Android Indoor Station Firmware Release Note

V2.2.26_build230830 (2023-09-10)

Firmware Basic Information	Firmware Version	V2.2.26_build230830
	Device Model	DS-KH9310-WTE1(B) DS-KH9510-WTE1(B)

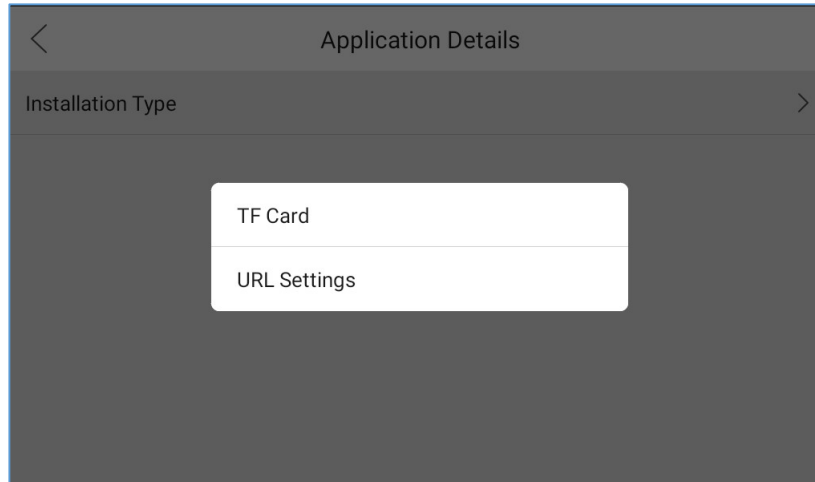
1. Support 16 indoor extensions.
2. Support 5 apps maximum (was 2 in previous version), total storage \leq 1 GB, RAM \leq 500 MB, CPU \leq 30%

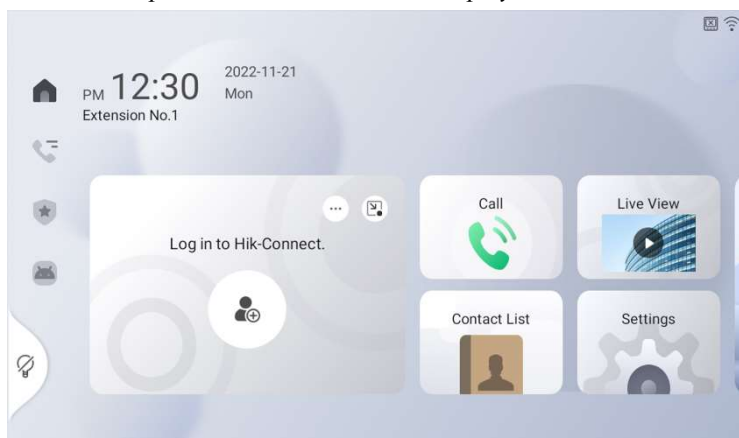
1. Indoor extension also supports internal Hik-Connect App.

- A. currently the HC login status can not be synchronized from indoor station to extension, you have to login manually on extension device.
- B. Internal Hik-Connect is a special version and will not display intercom devices in the list

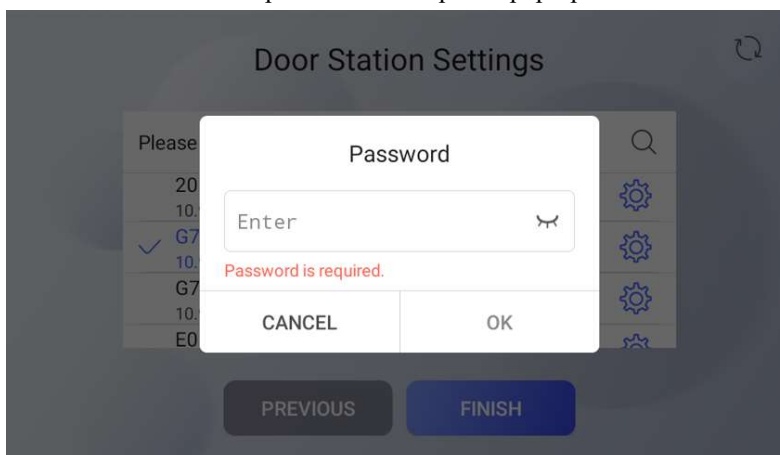
2. Add new function in wizard to check whether the activation password of the door and indoor station are the same, if not, it will prompt to enter the door station password in a separate pop-up box.

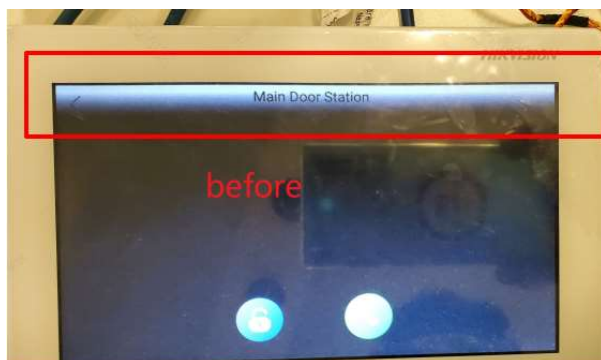
1. Change the gradient background at the top of the preview screen to transparent

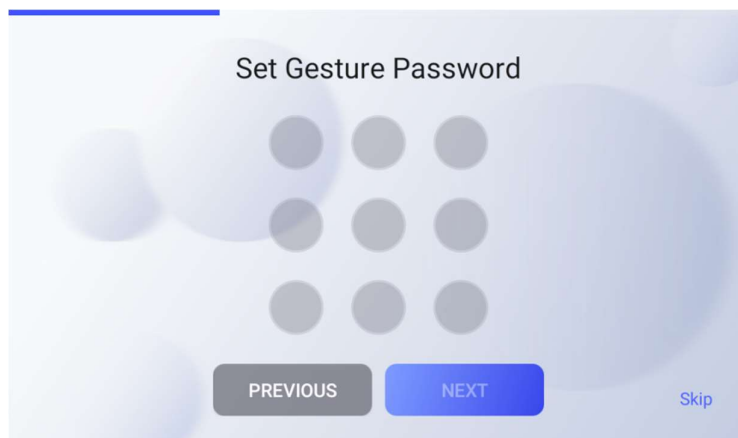
- 1) Support reset admin password via email or security questions.

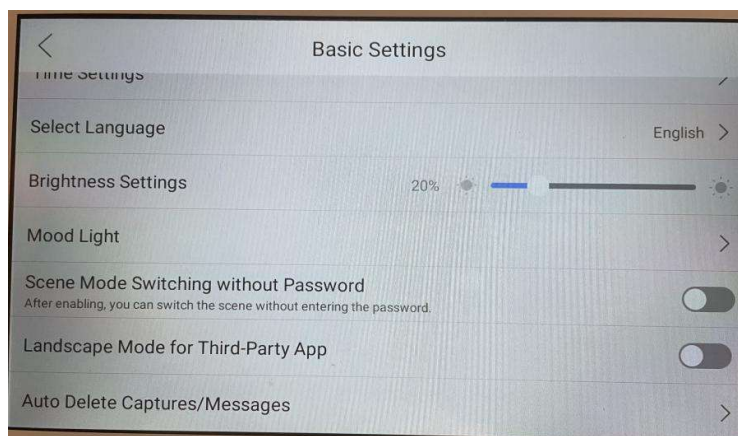
2) Support unlock via gesture.

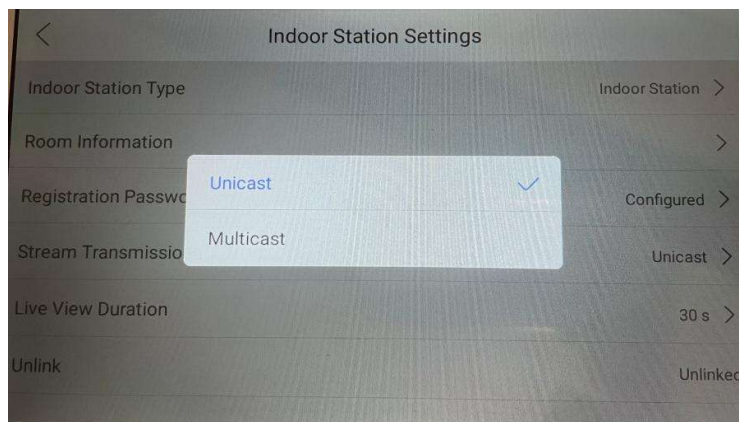
1) Support unicast and multicast options for video stream.

For multicast mode, the new version is supported up to 15 channels of video stream, but the switch or router must support the multicast mode at the same time, otherwise it can only support 6 channels of video stream.

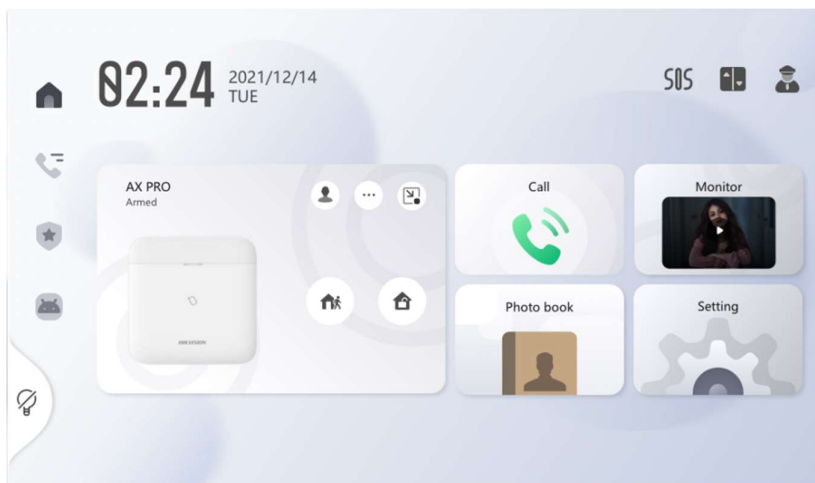
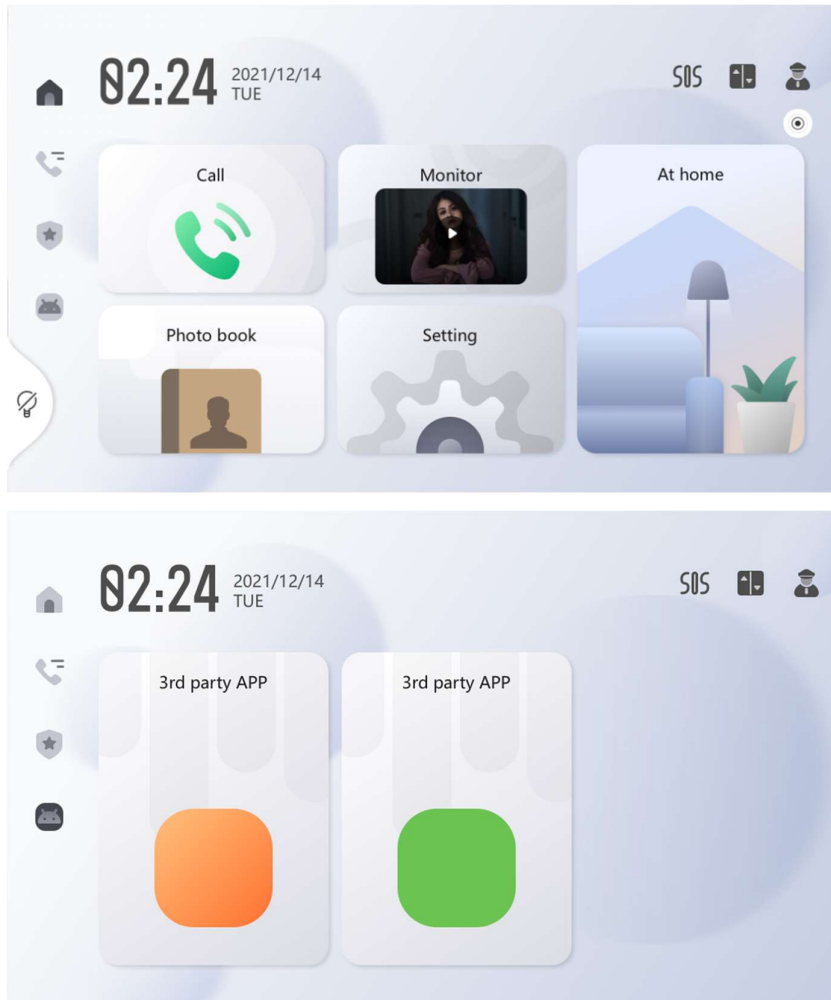
3) UI new style and optimization
